# **Design Process** Tie To Southwest Context

# Pre-ANC Feedback Zoning Hearing (October 1) Current Version

Project Name: 5M SW West Residential

### Revised 'Hyphen' Facade

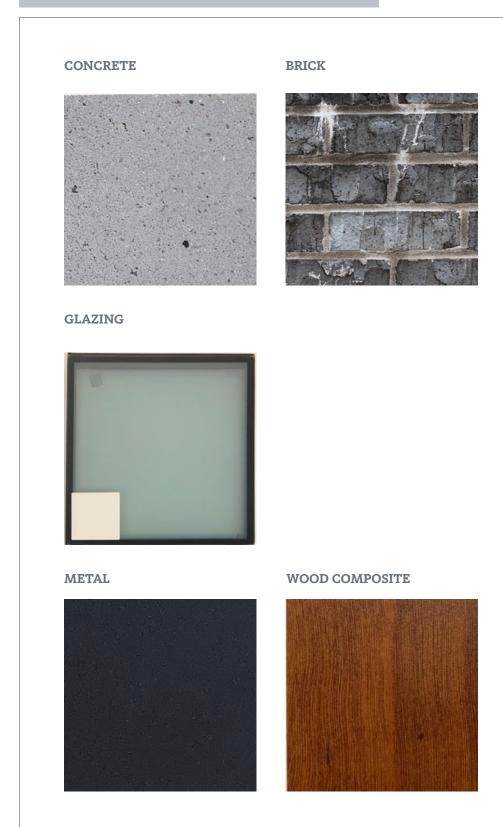
- Added balconies.
- Updated brick detailing to reflect the mid-century detailing prevalent in Southwest.
- Introduced additional reveals in the massing.
- Enlarged window openings / increased glass.

- Removed the precast grid facade to consolidate the design vocabulary.
- Added more balconies.
- Added reveals between podium and tower.
- Introduced the same facade type from the pavilion to new upper story setbacks to consolidate design vocabulary.

### Revised 'Hyphen' Facade

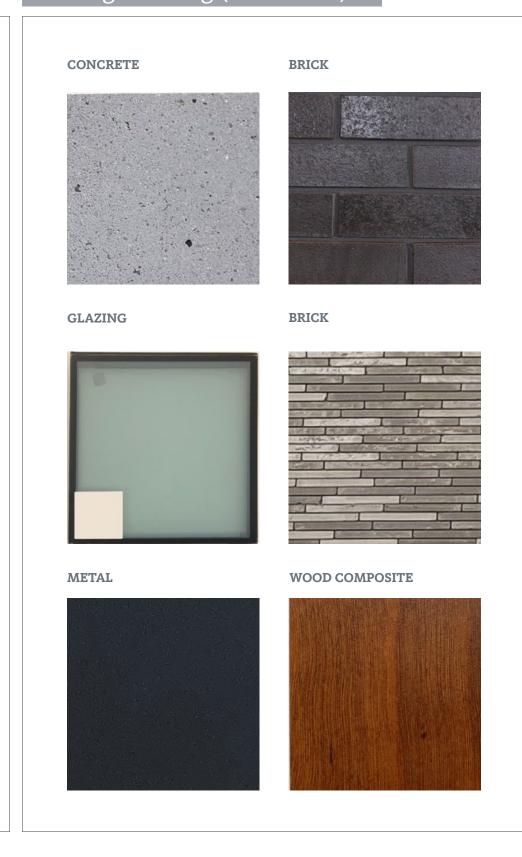
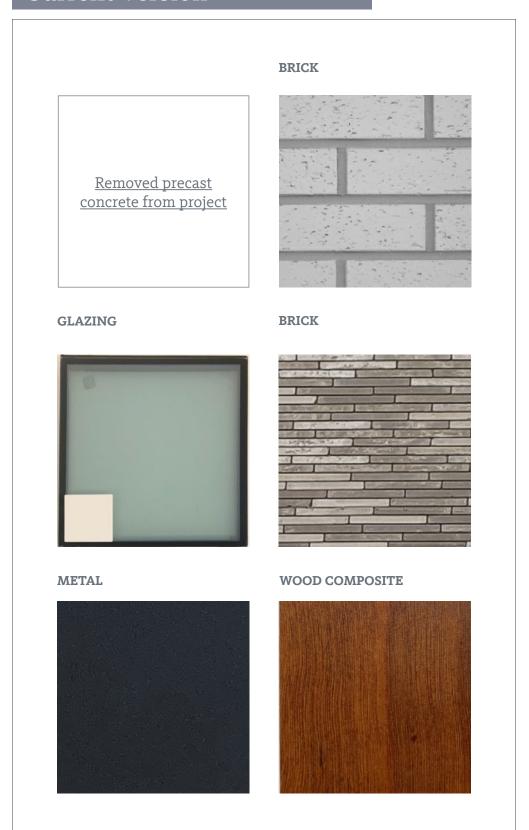
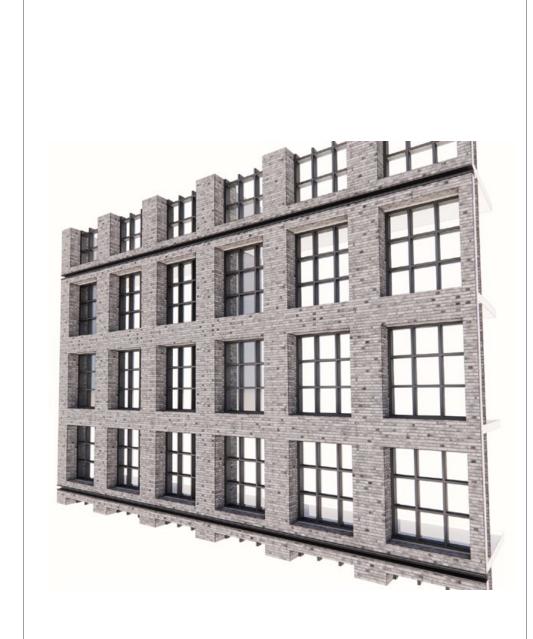
- Stacked bond brick creates a more mid-century aesthetic.
- Brick surfaces are captured by metal elements similar to midcentury references in the neighborhood.
- Increased glass and light.

- Replaced the dark charcoal brick with a lighter grey brick.
- Replaced metal spandrel with decorative brick.
- Revised balcony detail to evoke the rotated windows on the southeast building.

### Revised Pavilion

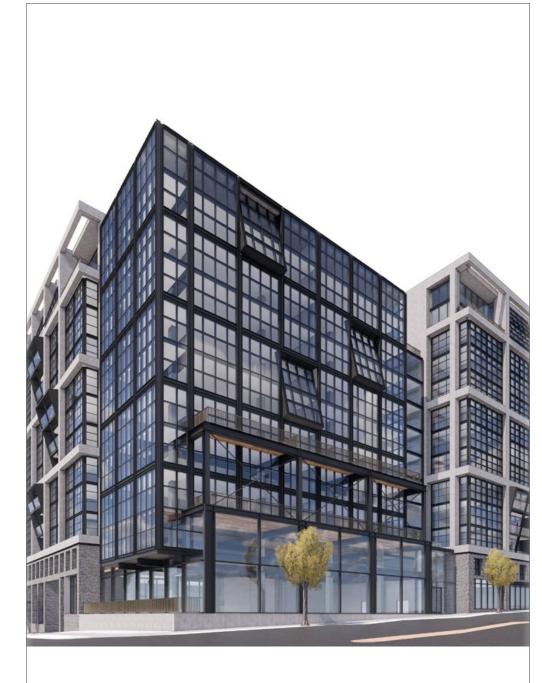
- Simplified the facade to exclude rotated windows and removed exoskeleton.
- Tiered the massing to allow for a more varied roofline.

- Removed the tiering of the pavilion to allow for open air porosity to courtyard.
- New brick facade type consolidated to the northwest building
- Added balconies to west facade.
- Added 3-story inset for southern views.
- New inset corresponds with new outdoor amenity at pavilion roof.

### Revised Pavilion

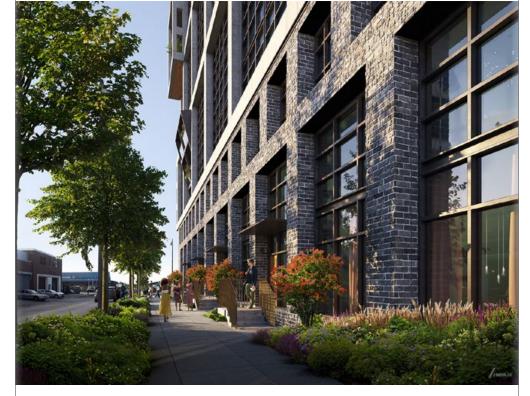
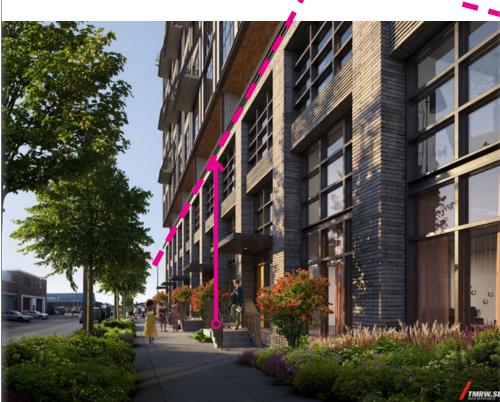
- Simplified the facade to exclude rotated windows and removed exoskeleton.
- Tiered the massing to allow for a more varied roofline.

• Removed the tiering of the pavilion to allow for open air porosity to courtyard.

### Revised Podium

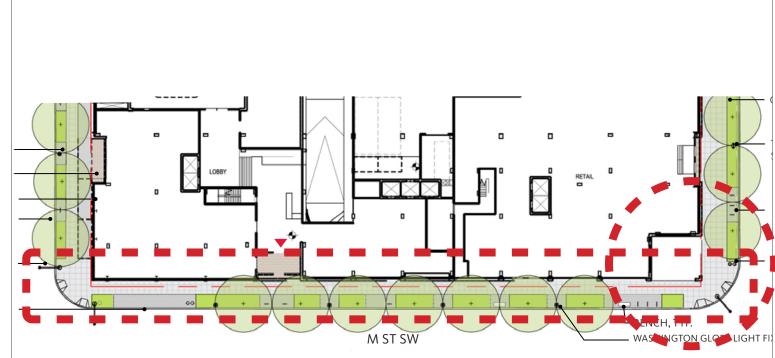
- Added a reveal at level 3 to better highlight a pedestrian-centric scale of the walk-up units.
- New reveal better associates the podium with low-rise neighbors.

### Revised Pavilion

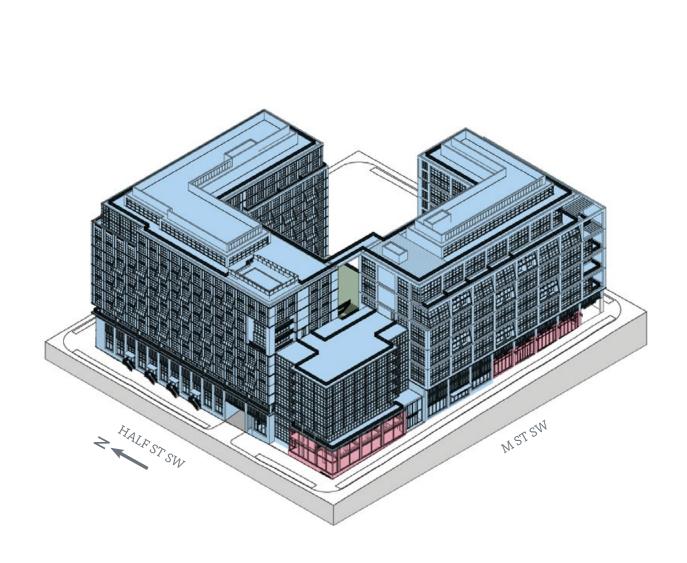
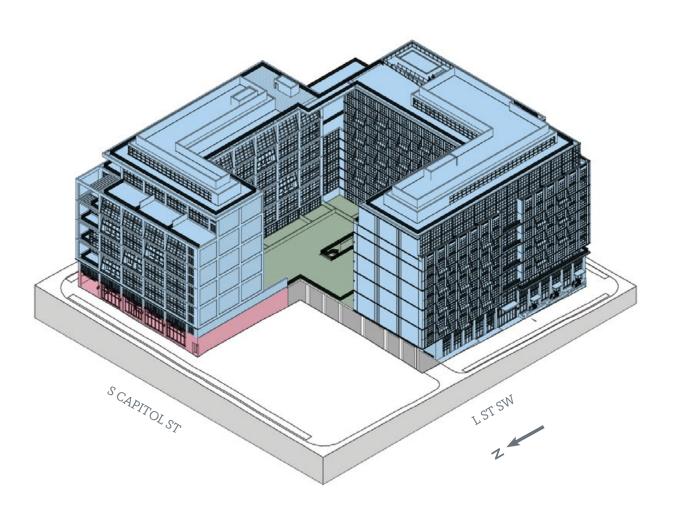
• Reduced the dimensions of the typical mullions to lighten the gridded appearance of the facade.

- Maintained lightened grid.
- Mirrored the rotation of the hopper balcony to lean inwards for both consistency across the non-balcony rotated windows, as well as to lessen the effect of the outward leaning version had on the pedestrians looking up at the building.
